# Access Compliance Report

## Public Rights-of-Way

### (Curb Ramps)

Intersection ID: 15839	Main Street: DORCHESTER_PL	Cross Street: SEDGEFIELD_RD	Location: NW
ADA ID: F36D74BFBD69	Ramp Type: Directional1	Initial Pass/Fail: Fail	Overall Compliance: No
			Severity Score: 13.75

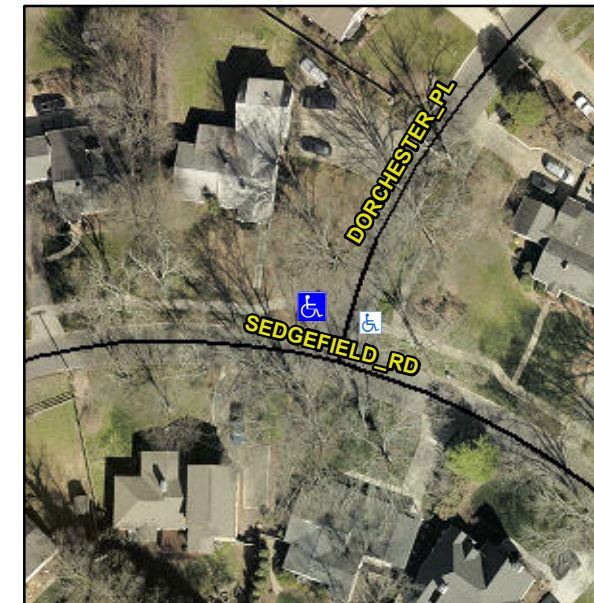
**R304.2.2, R304.5.3**

Compliance	Description	Data	Compliance	Description	Data
N/A	Ramp Length (in)	65.0	N/A	Grade Break?	N/A
Yes	Ramp Width (in)	48.0	N/A	Grade Break Slope (%)	0.0
No	Ramp Slope (%)	9.3	N/A	Grade Break XSlope (%)	0.0
No	Ramp XSlope (%)	4.5			
N/A	Flare Type LT	N/A	N/A	Flare Type RT	N/A
N/A	Flare Slope LT (%)	N/A	N/A	Flare Slope RT (%)	0.0
N/A	Flare Traversable LT?	N/A	N/A	Flare Traversable RT?	N/A
N/A	Landing Length (in)	0.0	N/A	DWS Provided?	N/A
N/A	Landing Width (in)	0.0	N/A	DWS Contrast?	N/A
N/A	Landing Slope (%)	0.0	N/A	DWS Length (in)	N/A
N/A	Landing X Slope (%)	0.0	N/A	DWS Full Width?	N/A
N/A	Landing Curb? (Y/N)	N/A	N/A	DWS Offset LT (in)	N/A
N/A	Shared Landing?	N/A	N/A	DWS Offset RT (in)	N/A
N/A	Gutter Ponding?	0.0	N/A	Gutter Slope (%)	N/A
N/A	Gutter Lip Ht (in)	0.0	N/A	Gutter X Slope (%)	N/A
N/A	Painted X Walk1?	No		Road Slope (%)	0.6
	X Walk 1 Direction	To E		Road X Slope (%)	3.5
	X Walk 1 Width (in)	N/A		Clear Space?	N/A

**Remove & Replace Entire Ramp.**
